**SUBDIVISION,  
PLANNED UNIT DEVELOPMENT,  
PLANNING APPROVAL, REZONING &  
SIDEWALK WAIVER STAFF REPORT**

**Date: February 7, 2013**

Pinecrest East Subdivision

1939 Dauphin Island Parkway  
(Northeast corner of Dauphin Island Parkway and Military  
Road, extending to the West side of Perimeter Road and to  
the South side of Neshota Drive)

SITE PLAN

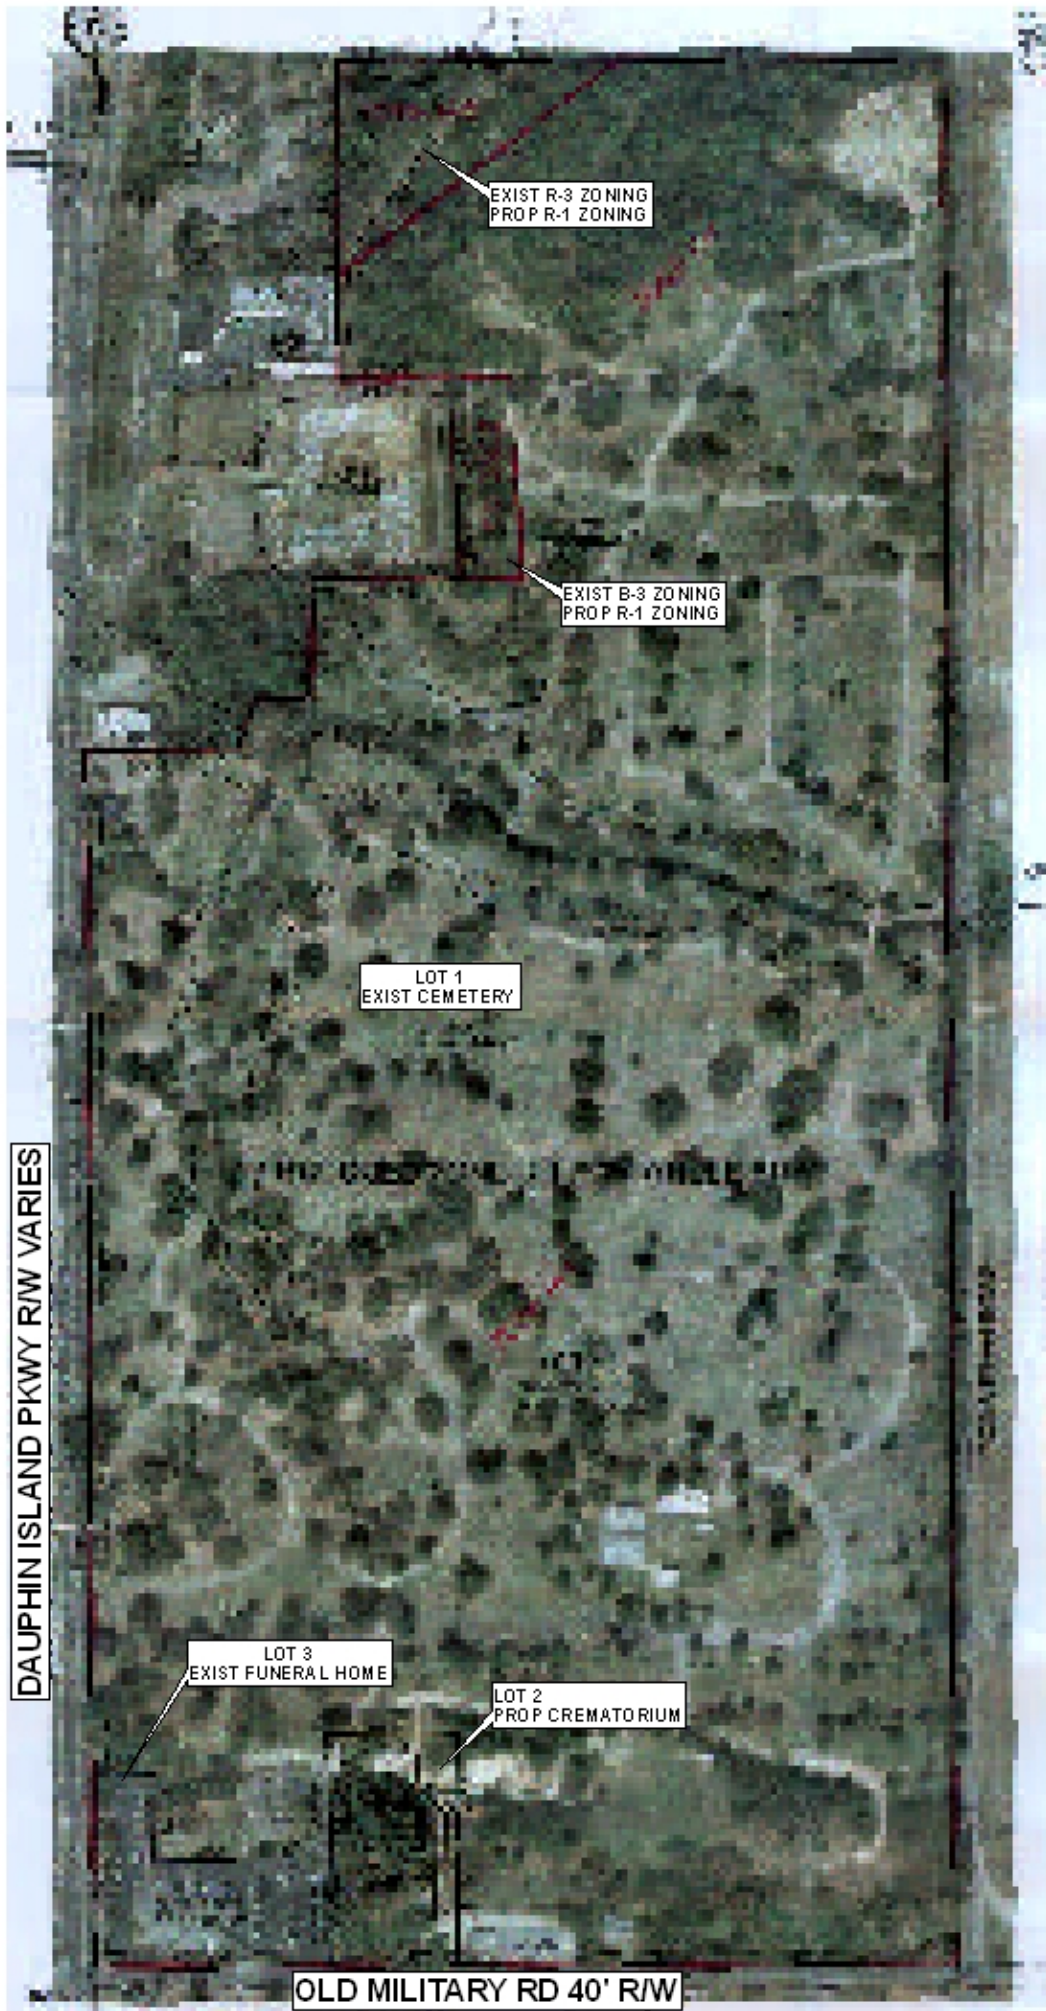
The accompanying site plan is incomplete, in that, it does not indicate parking, dumpster location, landscaping & trees and lighting. Current aerials illustrate six curb cuts to the development, three to Dauphin Island Parkway and three to Gatotkoco Drive (Old Military Road). With approximately 2,361 linear feet along Dauphin Island Parkway and 1,690 linear feet along Gatotkoco Drive (Old Military Road) the number of curb cuts is not an issue; however, a note should be placed on the Final Plat limiting the development to the existing curb

Currently, the site is developed with several structures; a funeral home, maintenance building, several mausoleums, the proposed addition of the crematorium and the proposed addition of six parking spaces on Lot 2; however, the site plan does not illustrate uses associated with any existing structures. Landscaping and trees are not illustrated on the site plan, which would illustrate the size and type of trees that could be used for credits and if the site meets the minimum landscaping and tree planting requirements of the Ordinance; however, the majority of the site is landscaped and has numerous large trees and should not have a problem complying with the Ordinance. As such, full compliance with the landscaping and tree planting requirements of the zoning ordinance would be required.

Lot 2 is the only lot with proposed construction, the plan illustrates no other improvements to the site, such as surface for parking and maneuvering, lighting, buffering and the provision of dumpster facilities. The site abuts a residentially zoned and developed R-3 district to the north; a buffer compliance with Section 64-4.D.1. of the Zoning Ordinance should be provided.

- 1) submittal of a detailed narrative describing the project in detail as required in Section 64-5.D. of the Zoning Ordinance;
- 2) revision of the site plan to show **ALL** improvements on the site, including, but not limited to, dimensions of parking stalls or drive aisles, indicate paving materials, and indicate the seating capacity of the funeral home and other information needed to ensure parking compliance;

- 3) depiction of dumpster locations on the site plans to comply with Section 64-4.D.9 of the Zoning Ordinance or placement of a note on the site plans stating that dumpsters will be completely screened from view and connected to sanitary sewer or placement of a note stating how garbage will be removed;
